DESCRIPTION:
Ltr re proposed changes to Appendix A of Tech Specs, trans the following:

ENCLOSURES:
Rev pages 117 thru 128 & page 130, encompassing paragraphs 6.1 thru 6.5 of Tech Specs for Nine Mile Point Nuclear Station, Unit # 1.

PLANT NAMES: Nine Mile Point Nuclear Station

Re: Provisional Operating License: DPR-17
 Docket No.: 50-220

FIGURE 6.1.1

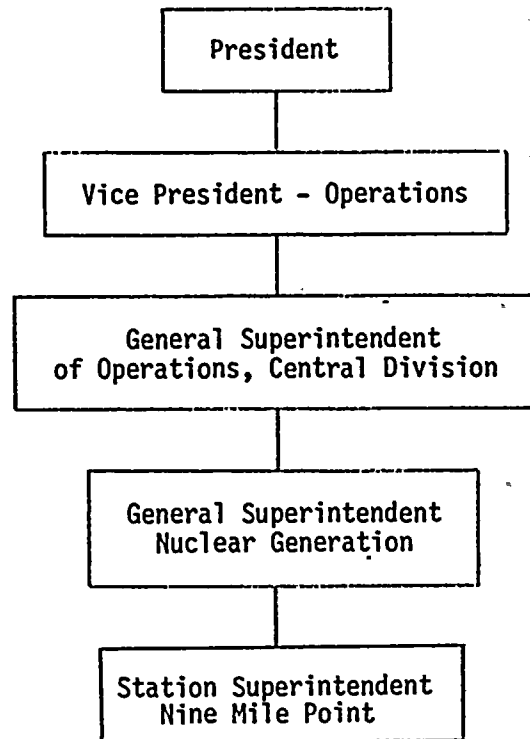
Figure 6.1.1

The General Superintendent, Nuclear Generation is added.

FIGURE 6.1.2
NMP-JAF NUCLEAR SITE
OPERATION ORGANIZATION

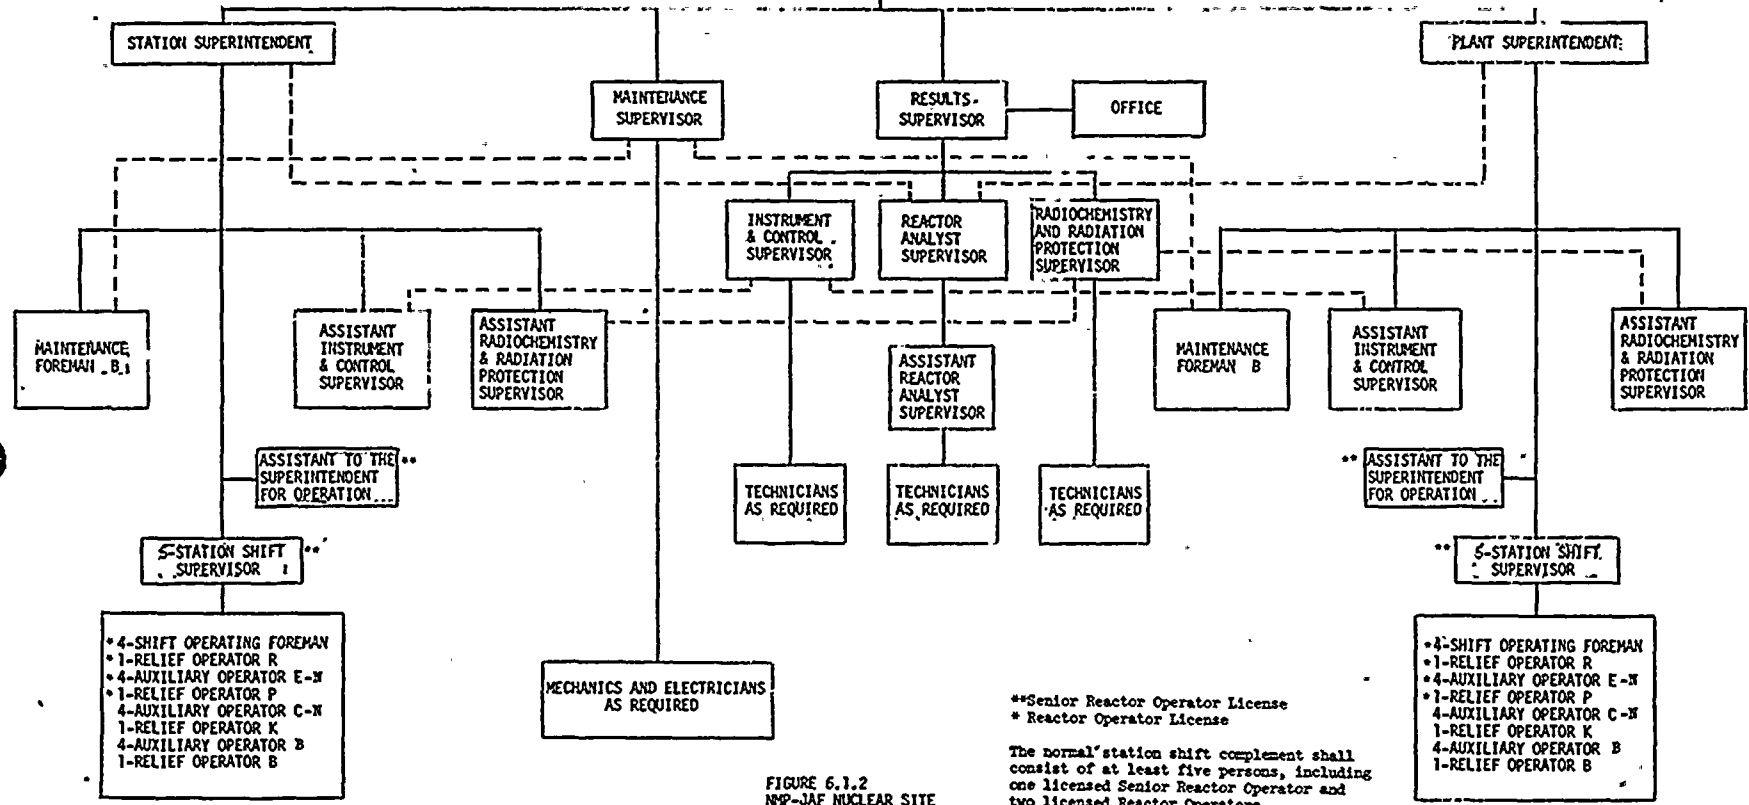
Figure 6.1.2

The organization for both the Nine Mile Point Nuclear Station and the James A. FitzPatrick Nuclear Power Plant are shown on Figure 6.1.2 because a general staff is provided for administrative and technical support to both stations. Each station has an organization which is self sufficient in the routine functions of operation maintenance and repairs. Implementation of the support functions is administered by the station superintendent

Figure 6.1.2
(Continued)

through the maintenance foreman "B" for mechanical and electrical repairs, and through the assistant instrument and control supervisor and the assistant radiochemistry and radiation protection supervisor in their respective disciplines. This relationship is shown in solid lines in Figure 6.1.2. Functional control is exercised by supervision from the general staff. Assignment of repair personnel or technicians to each plant is based on work requirements.

FIGURE 6.1.3
SAFETY ORGANIZATION
NINE MILE POINT NUCLEAR STATION
NIAGARA MOHAWK POWER CORPORATION

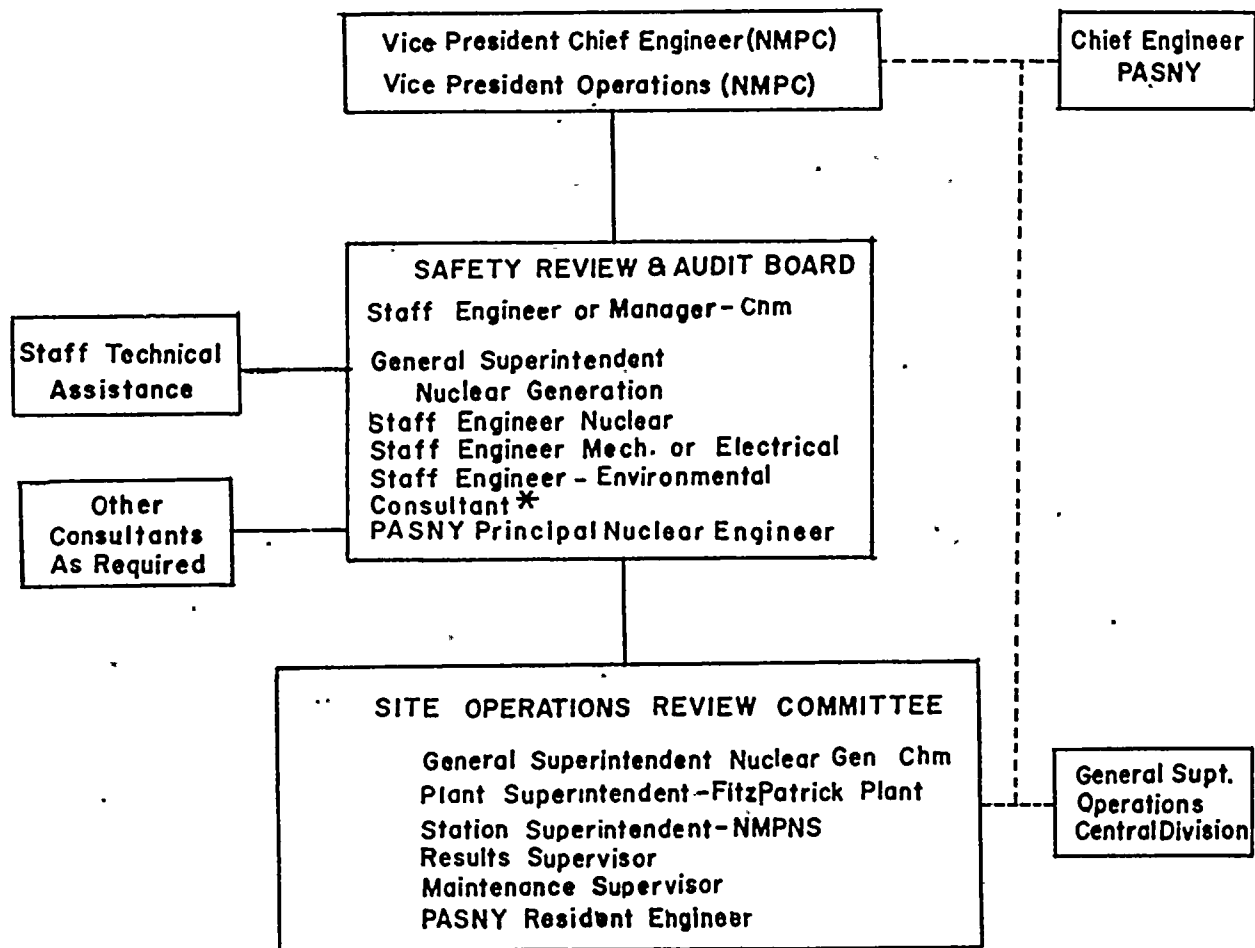
Figure 6.1.3

As noted in paragraph 6.1.b.(3)(b), the General Superintendent, Nuclear Generation is added to both the Safety Review and Audit Board and the Site Operations Review Committee. The Station Superintendent is removed from the Safety Review and Audit Board but retained on the Site Operations Review Committee. The PASNY Principal Nuclear Engineer is added to the Safety Review and Audit Board and the PASNY Resident Engineer is added to the Site Operations Review Committee. The Station Superintendent, PASNY, FitzPatrick Plant, is also included in the Site Operations Review Committee. The Chief Engineer, PASNY, is added in a management support function.

Figure 6.1.4

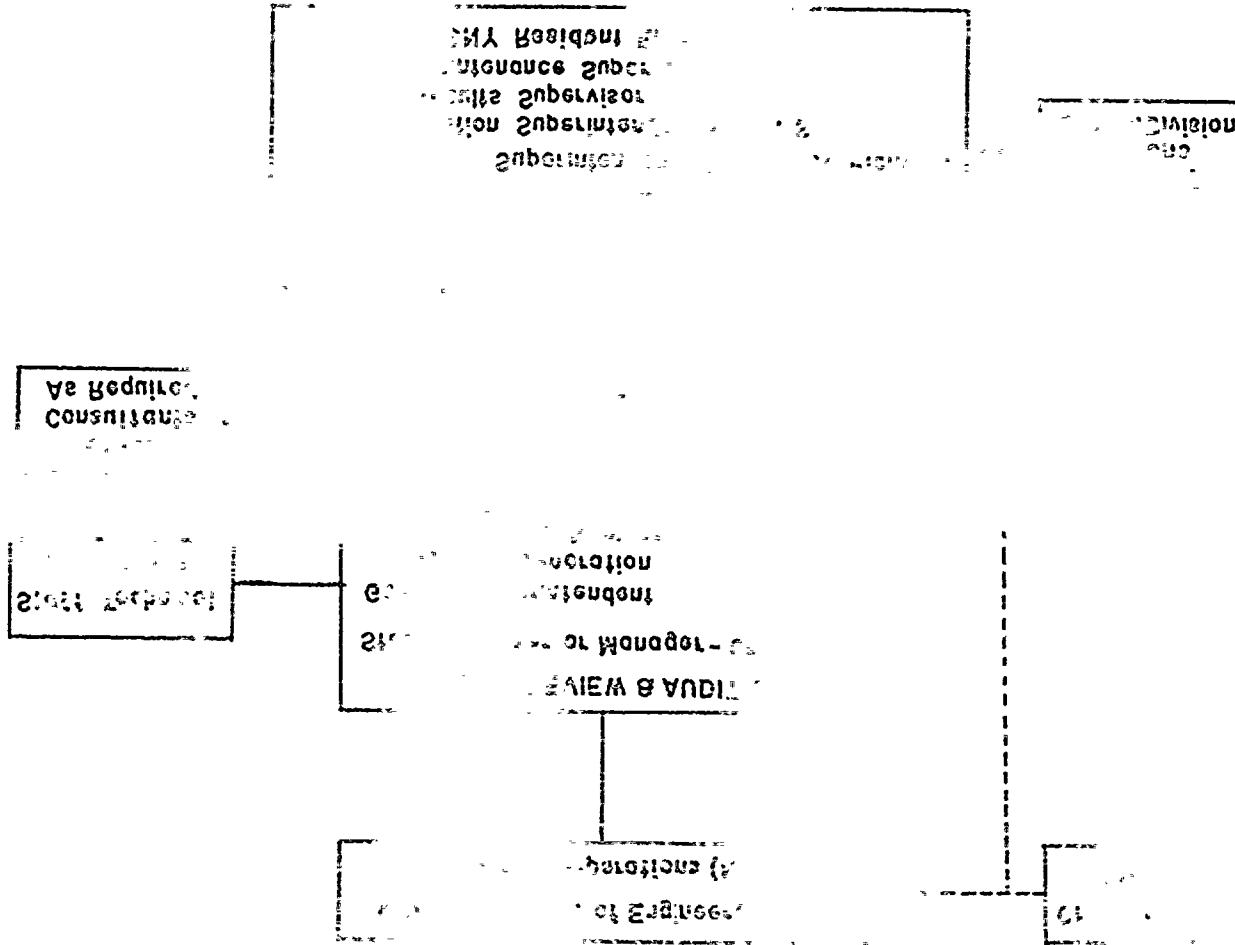
Figure 6.1.4

The Station Operations Review Committee is changed to Site Operations Review Committee.
